Appendix A2

Scoping Meeting Comments

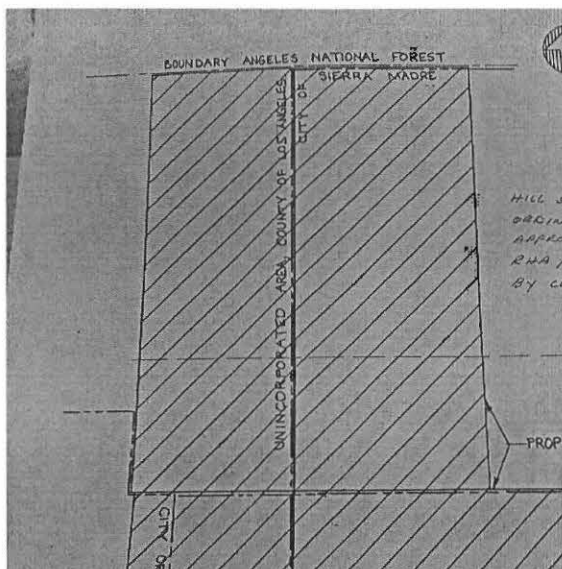
Those parcels should NOT be accepted by the City without a presentation to the people as to whether the acceptance would actually provide a benefit or be more of a liability.

One of those parcels directly above the monastery is already zoned Hillside and too steep to build under our Hillside ordinances. Our Hillside ordinances have always been strengthened, never weakened. It will remain protected.

It is NOT near Bailey Canyon trails for access. The retreat center will be gated from the housing development so there will be no access through their property. It is steep with brush and in the highest fire danger zone there is; it includes earthquake landslide zones on a Seismic Hazard map. There is NO advantage to the City or its citizens, in accepting ownership of already protected land. The benefit is to the Monastery.

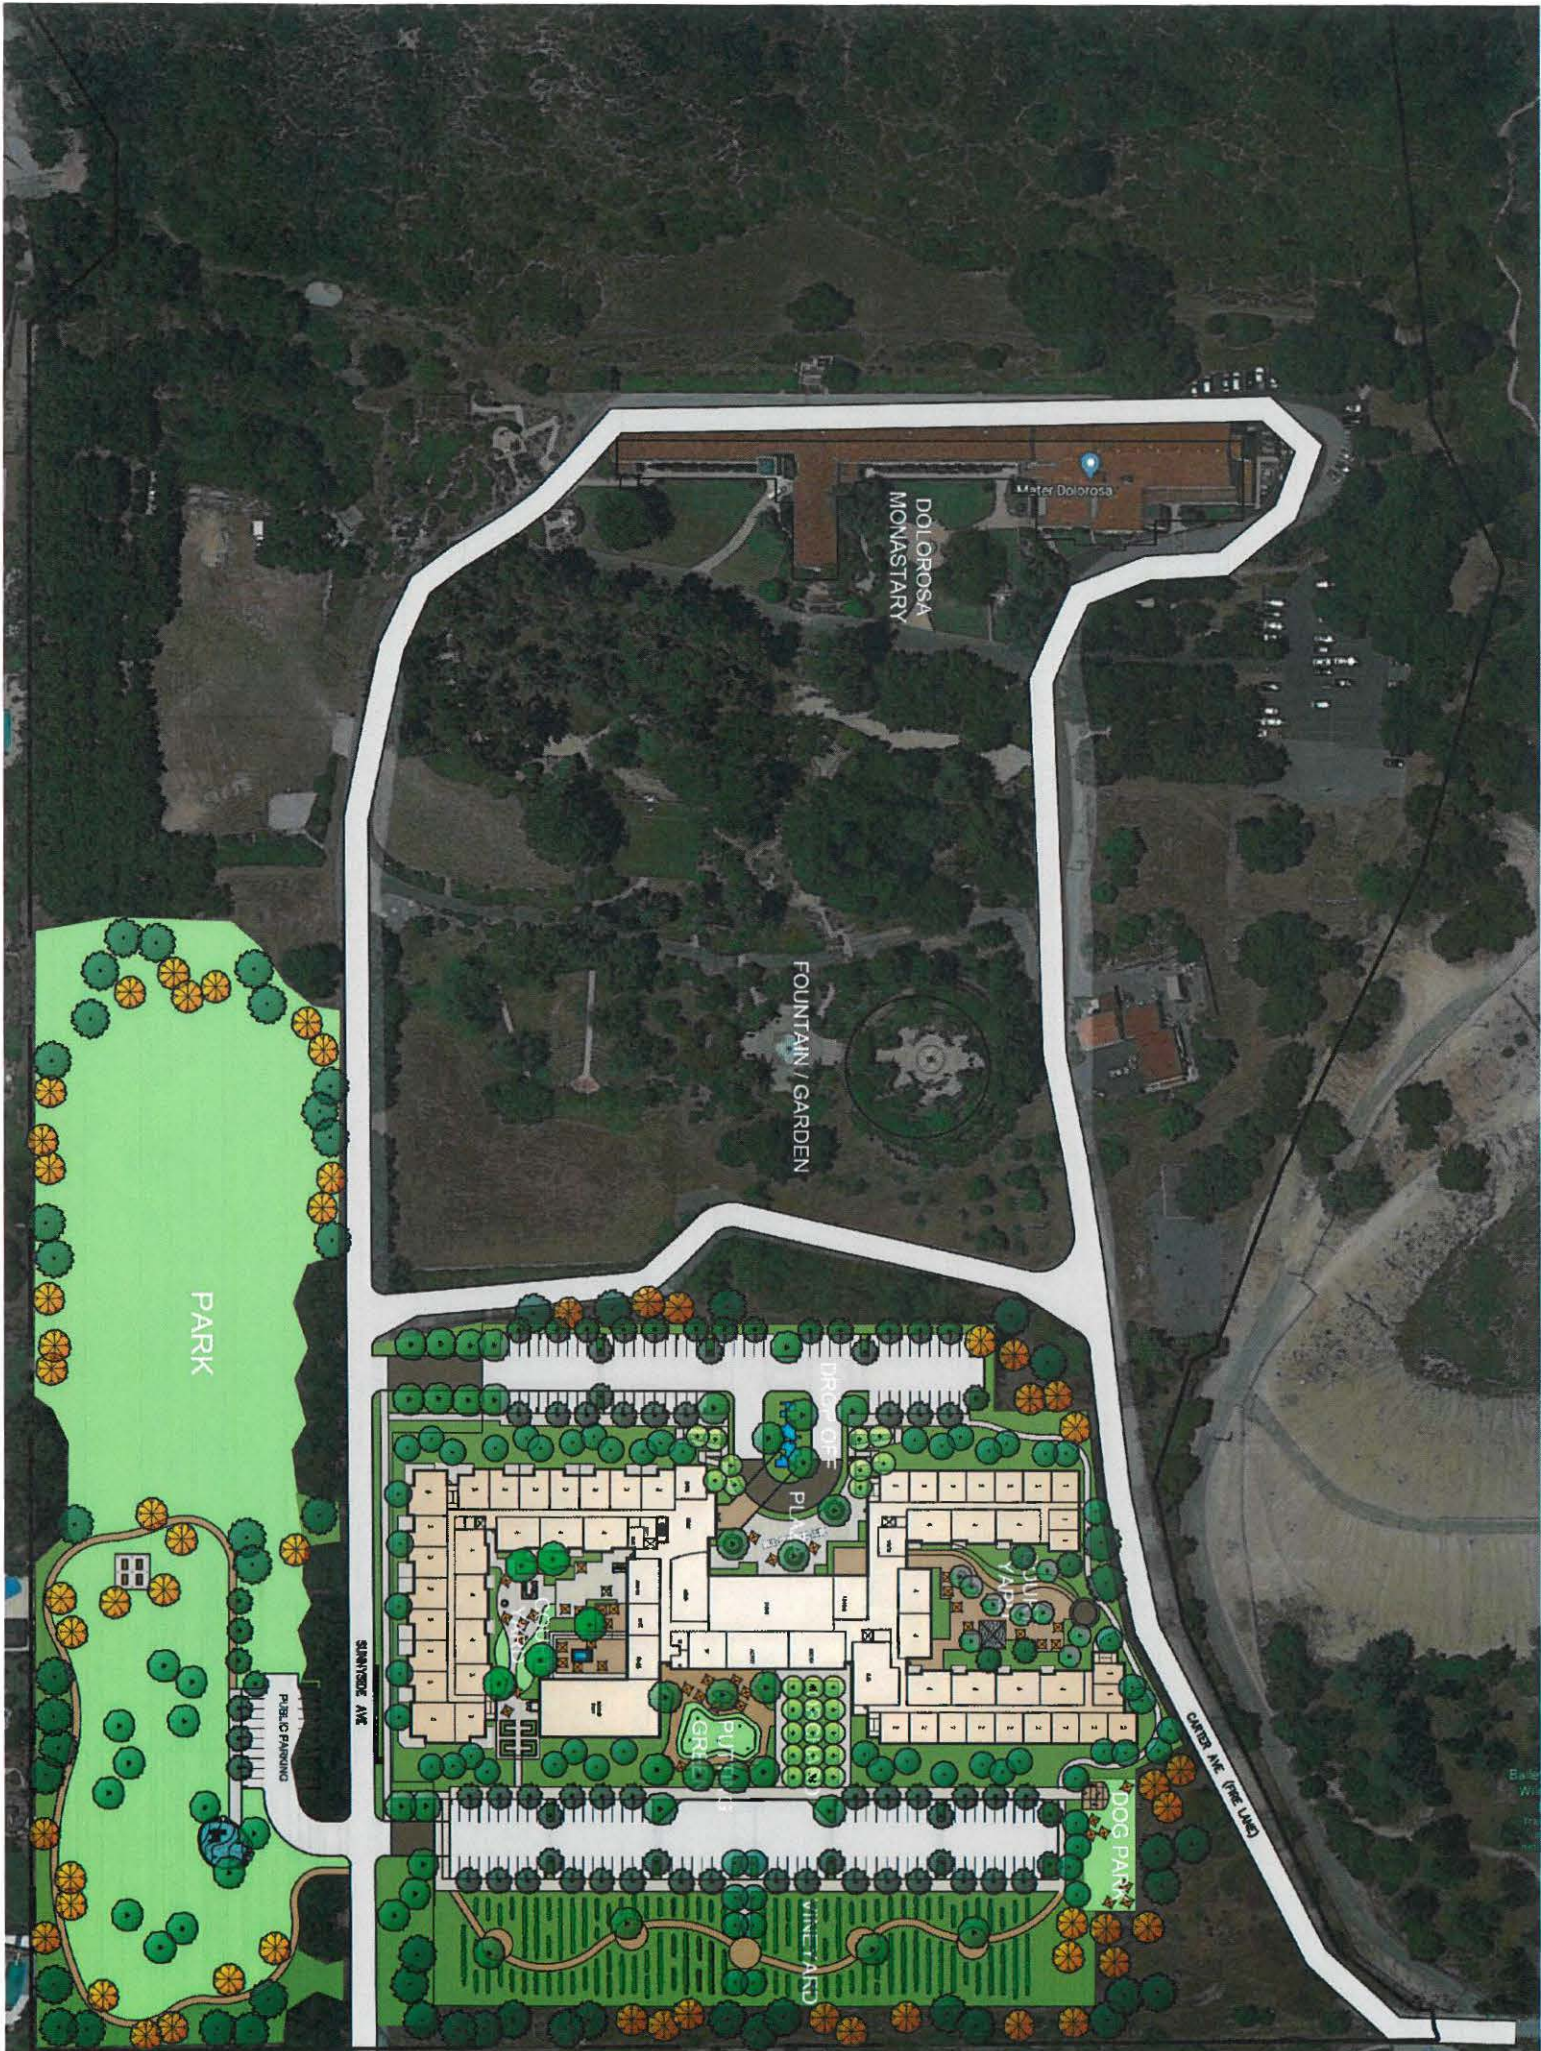
5. The institutional option has been mischaracterized as an 800-unit multi-story monstrosity with traffic counts estimated at 1,000-2,000 trips per day. This "scare tactic" is a disingenuous attempt to intimidate residents that institutional options would be much more detrimental than the NUW development. That is not the case as is illustrated by the attached conceptual assisted living plan. The traffic from existing assisted living projects in Sierra Madre is minimal (the Kensington and Sierra Vista) – the planners already know this, but elected to project misleading traffic counts if institutional use was approved.

9. The planning department will take the position that the City needs to add residences due to RHNA requirements. Assisted living units also qualify as living units.

In summary, it is very disappointing that the City planning department and council ignored the neighbors' prior objections, knowing that there has been heavy opposition to the NUW project since 2006. This process has been an overreach by the planning department and City of Sierra Madre. It is time to reconsider other options for the site that have far less impact and will not make the neighbors' lives miserable. The City's planning department and council have a fiduciary responsibility to protect their residents, not maximize sale proceeds for Mater Dolorosa and profits for NUW.
